ADDENDUM NO. 04 (MEPT)

Date of Issuance: April, 23, 2026

Project: **Replacement Elementary on Mustang Rd.**
Alvin Independent School District

Texas Arcadis Inc.
Project No.: 202502 - 30268973

M5.06
MECHANICAL
CONTROL
SCHEMATICS

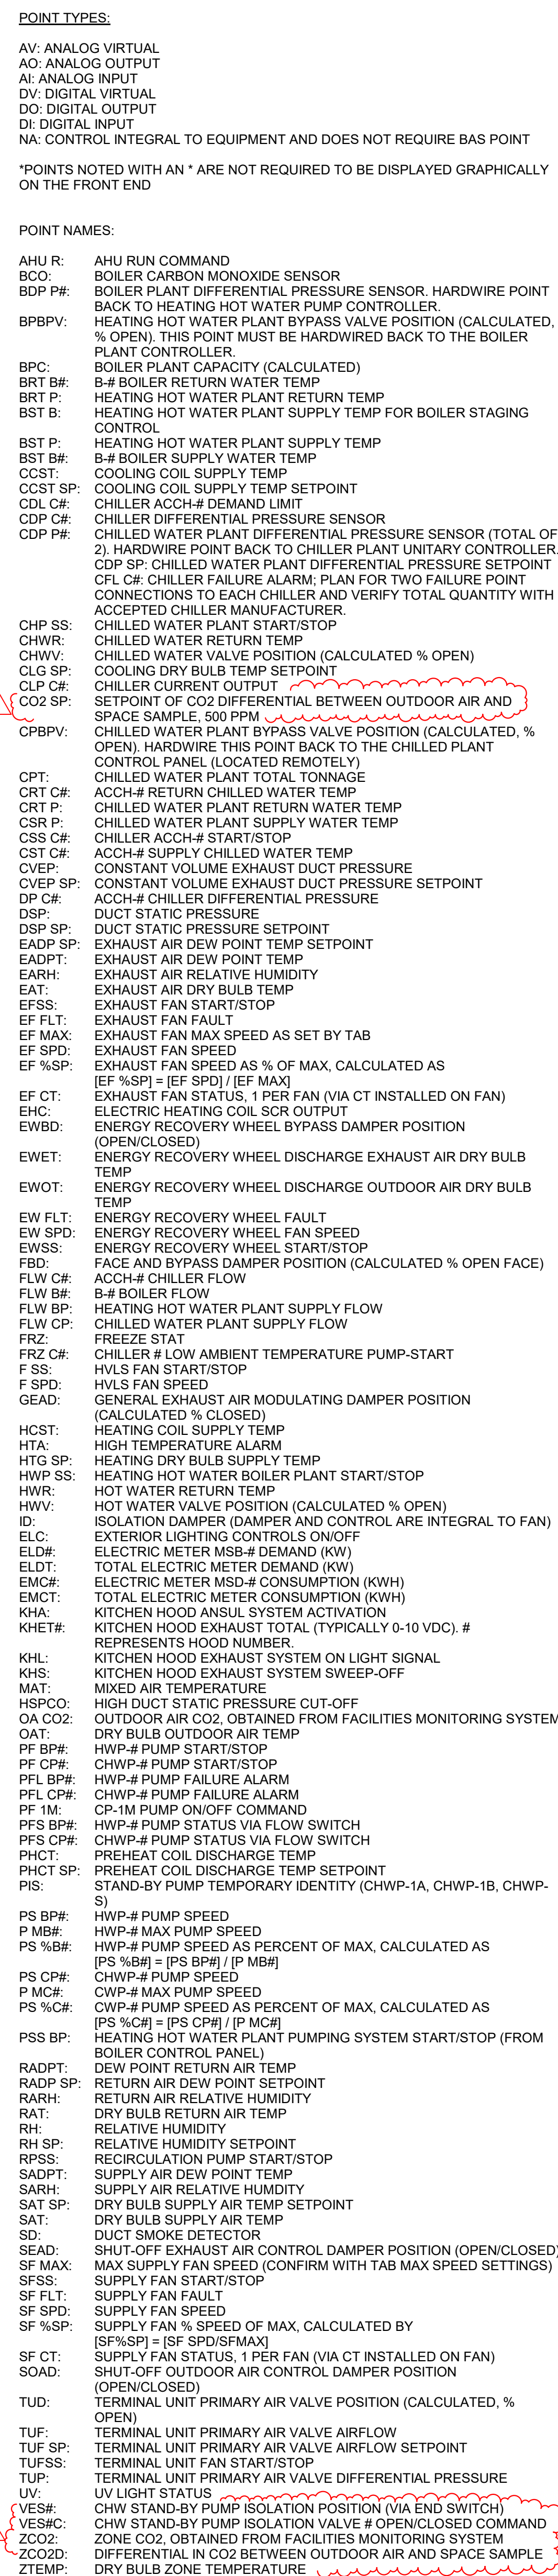
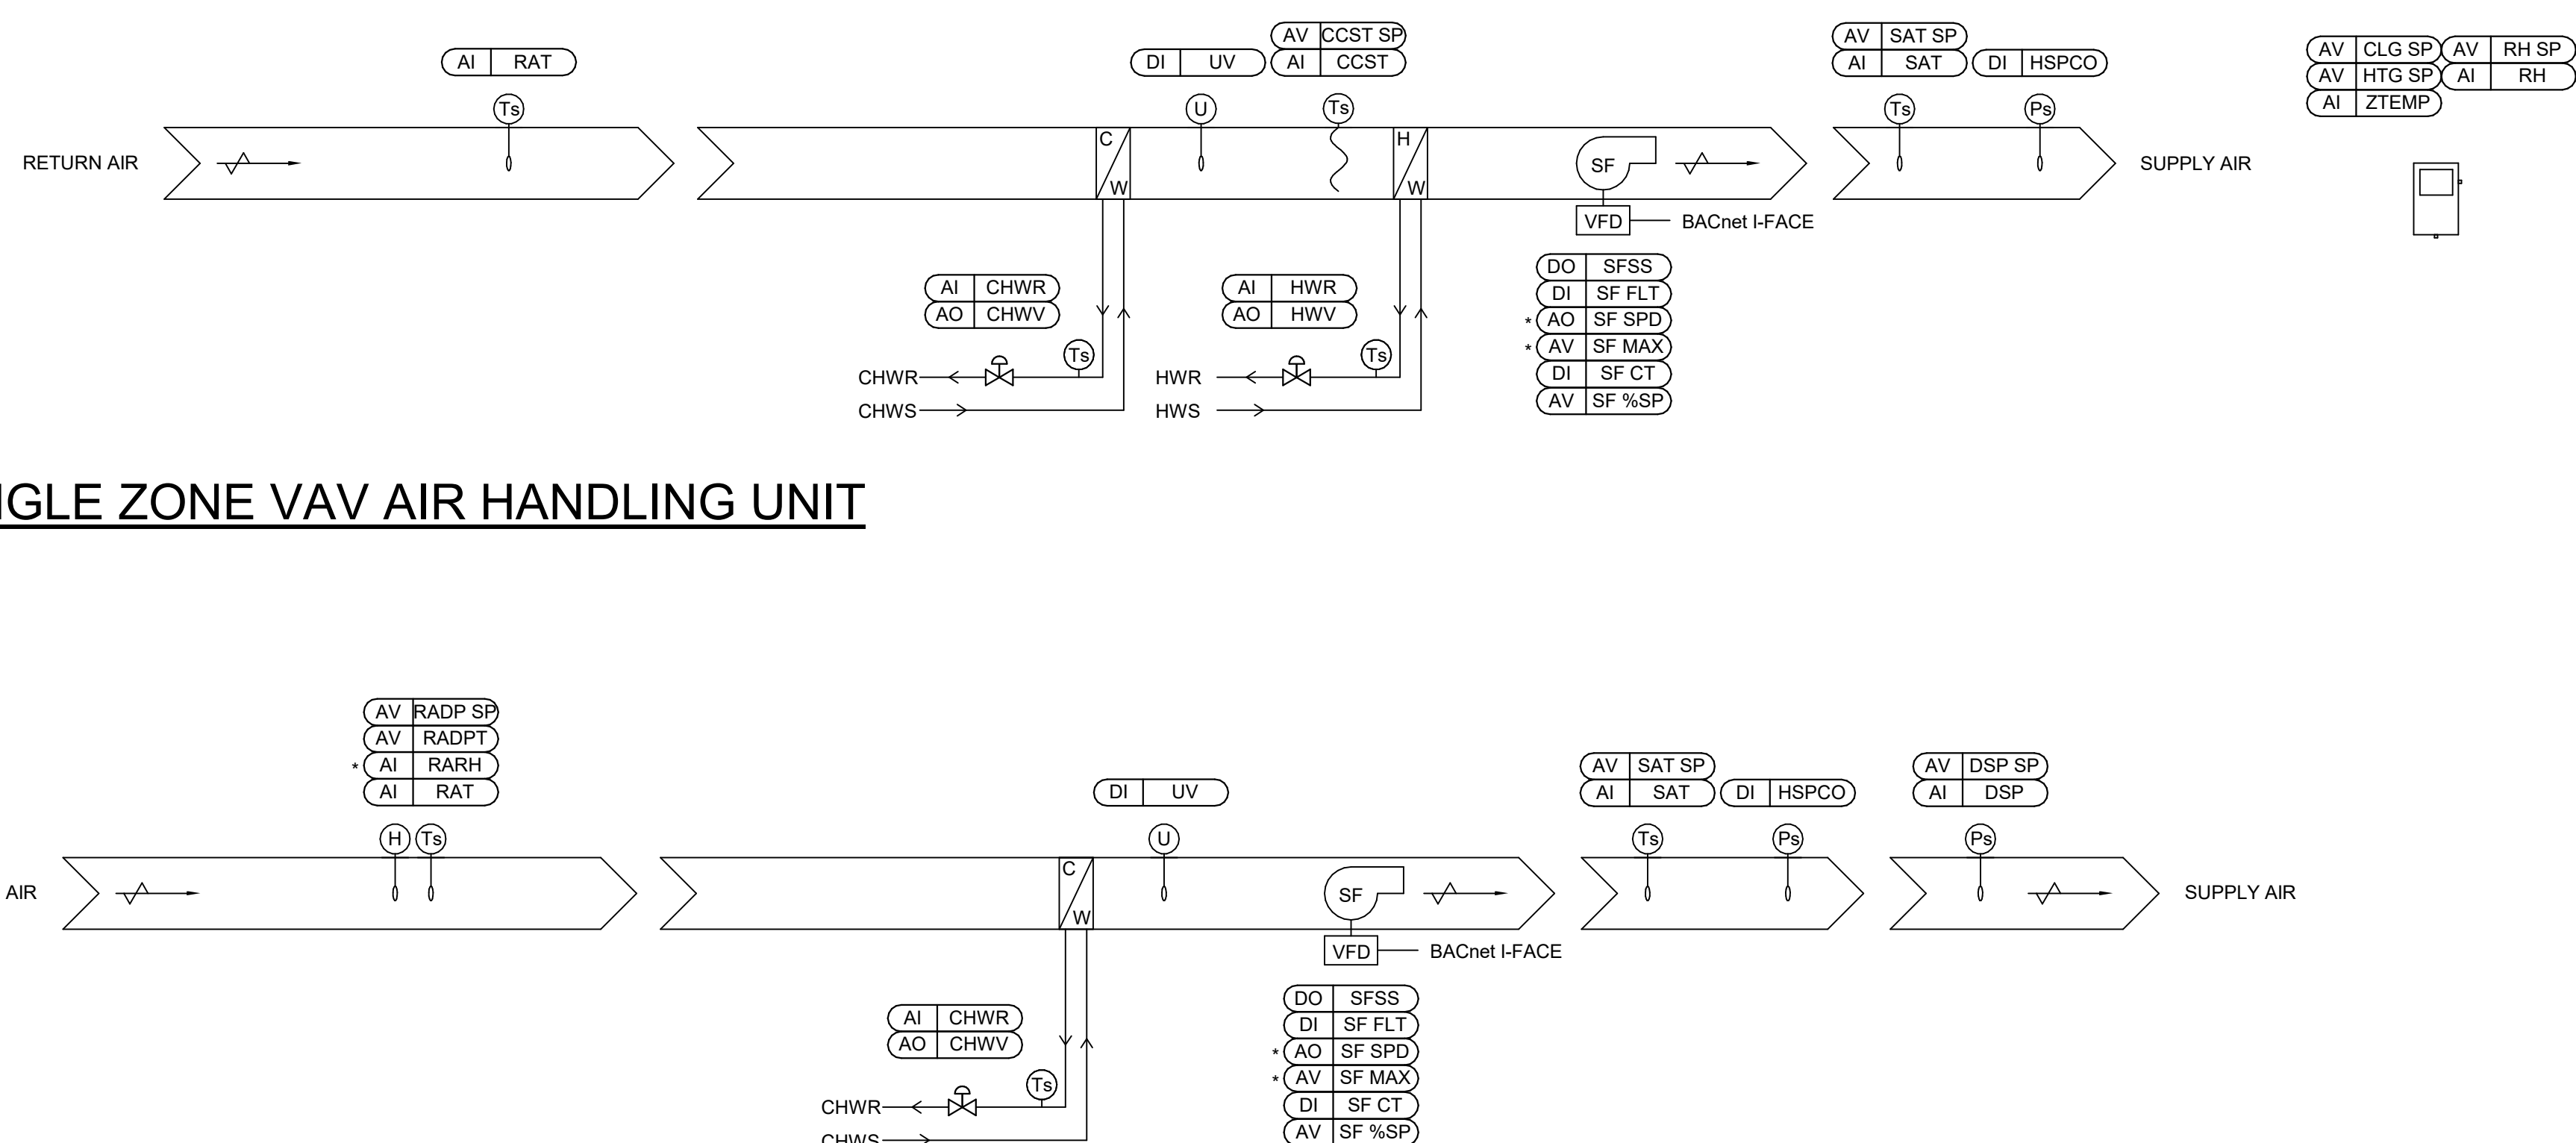
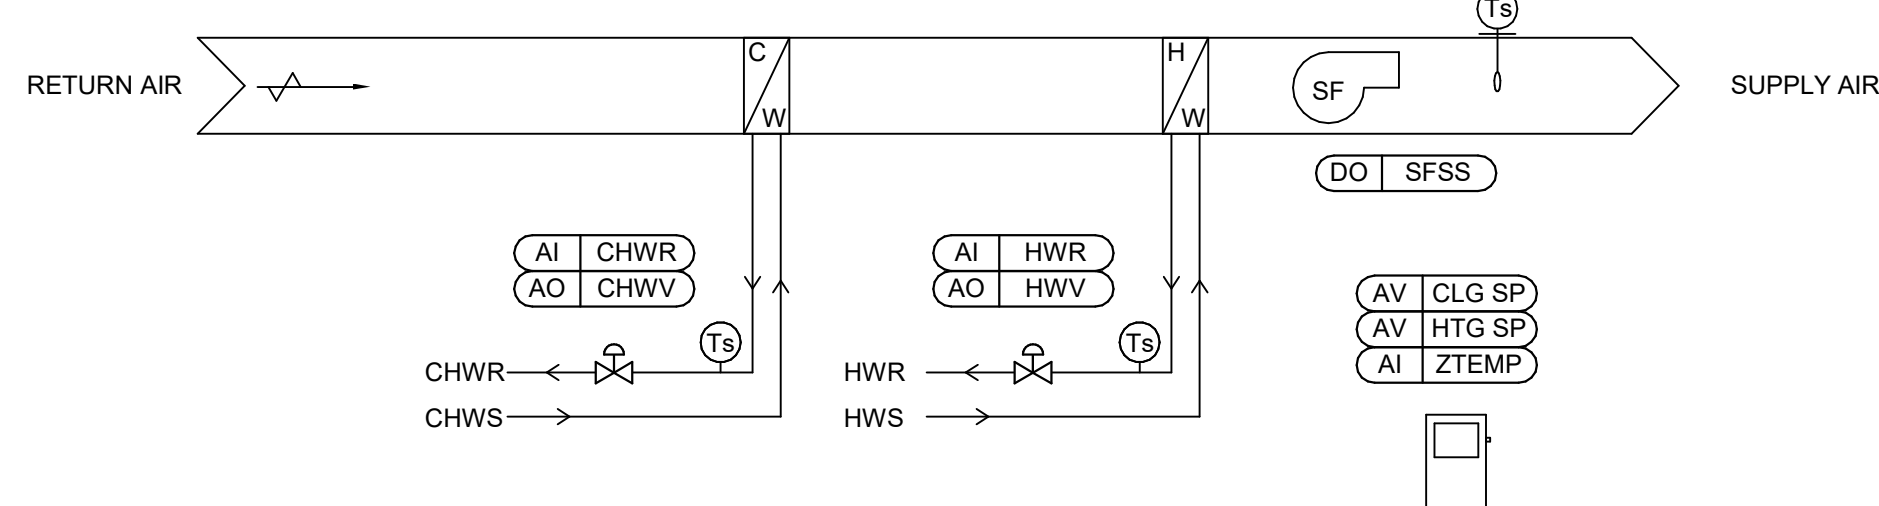
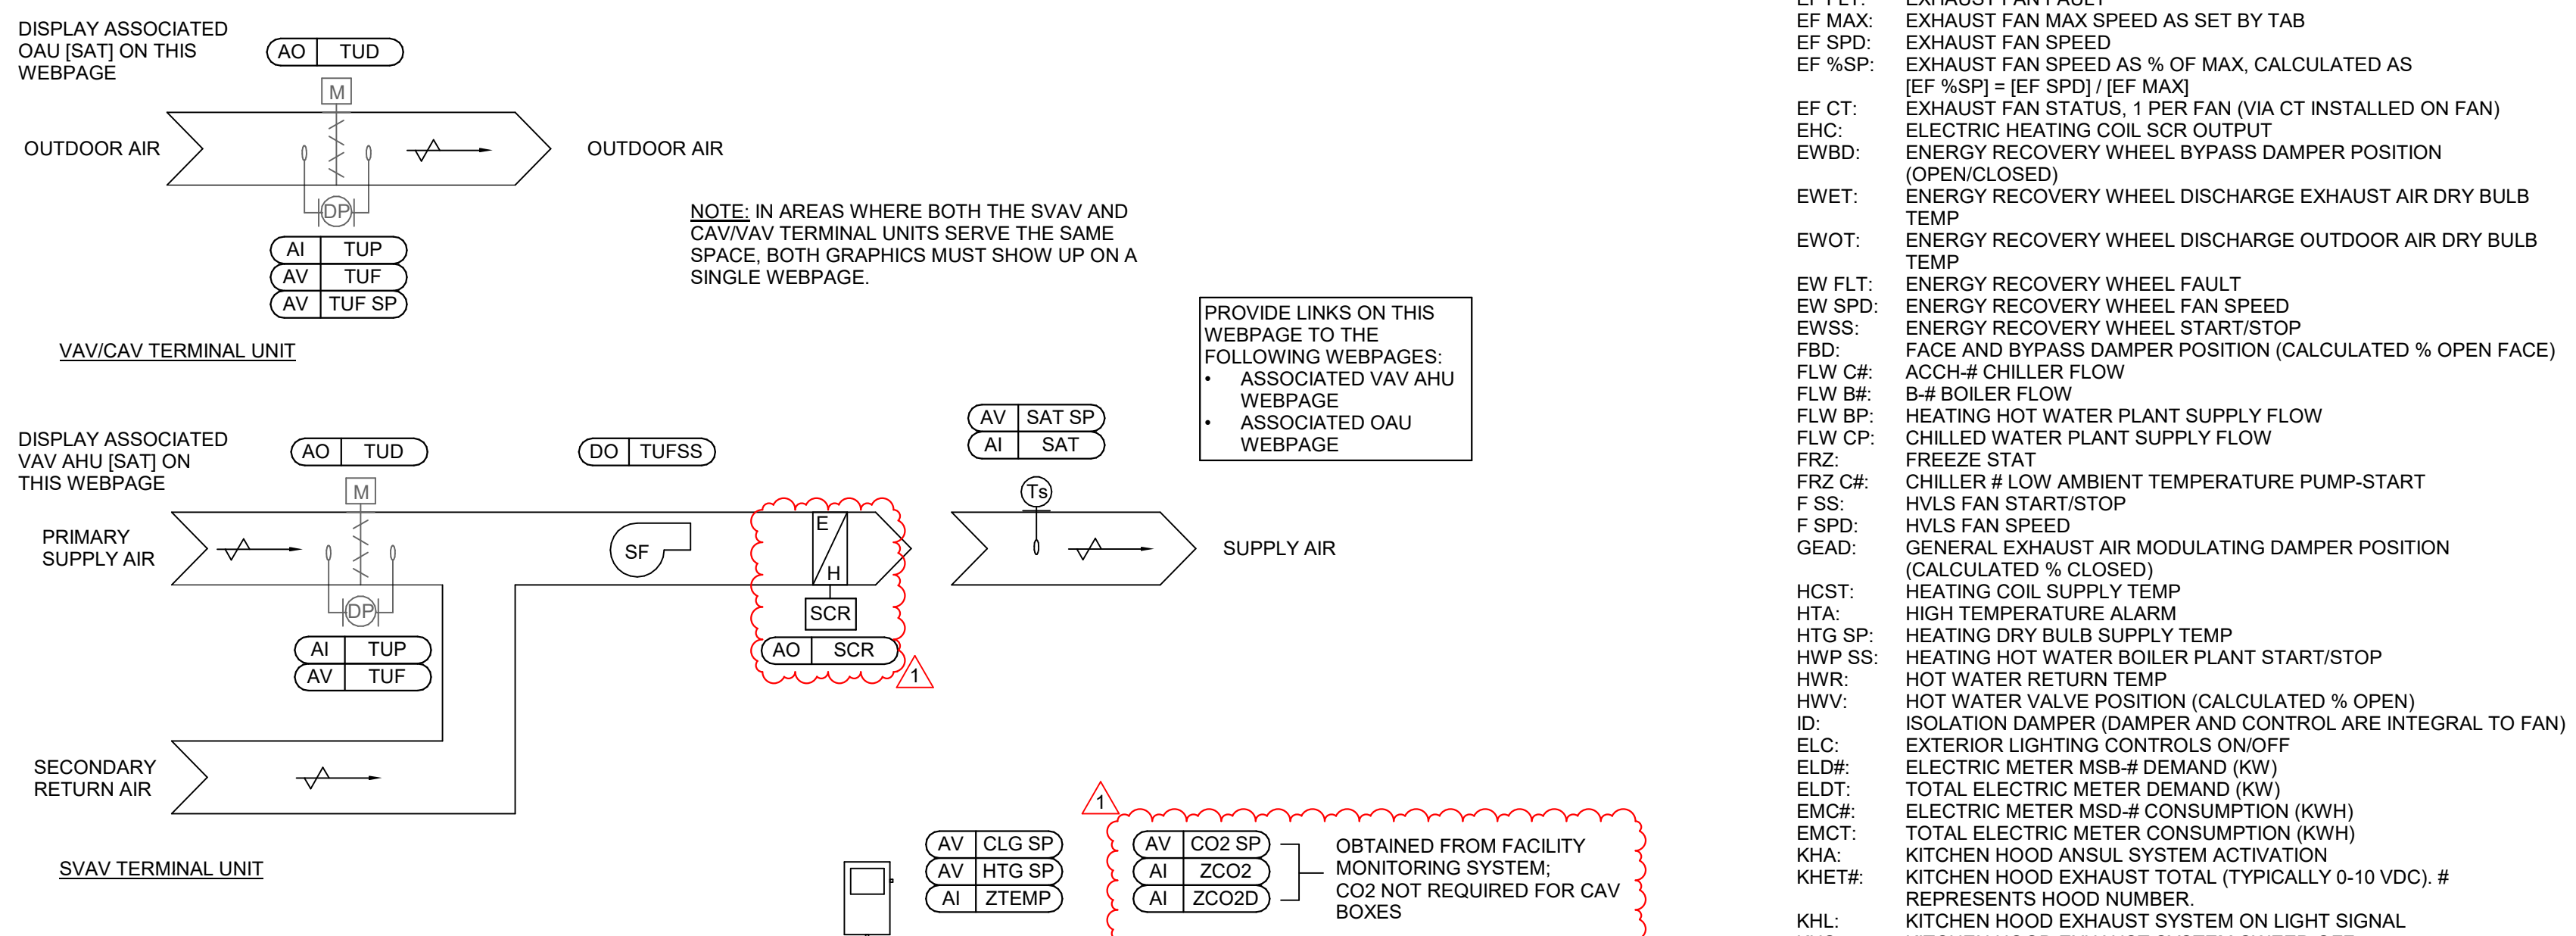
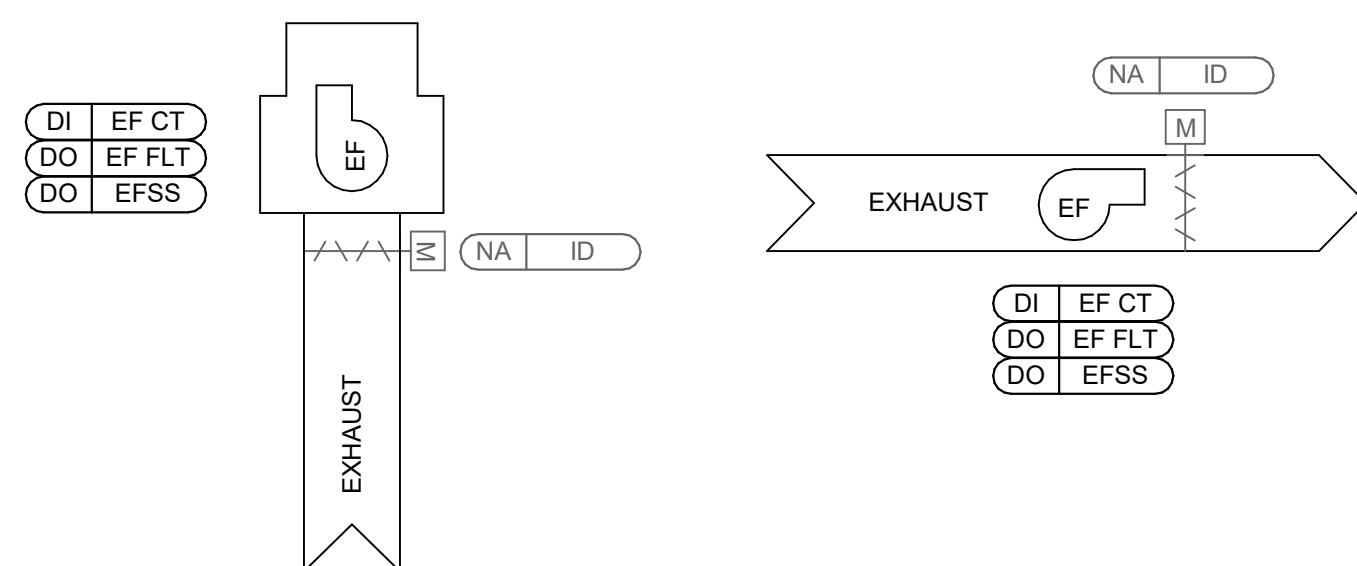
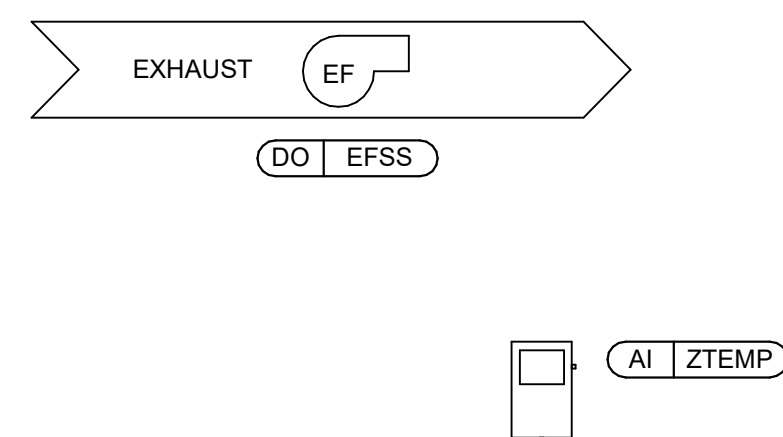
45. Sheet M5.06 – MECHANICAL CONTROL SCHEMATICS
 - a. Added [VES1C] and [VES2C] for open/closed command position of stand-by pump isolation valves.
 - b. Added [PF 1M] start/stop status for sidestream filter pump.
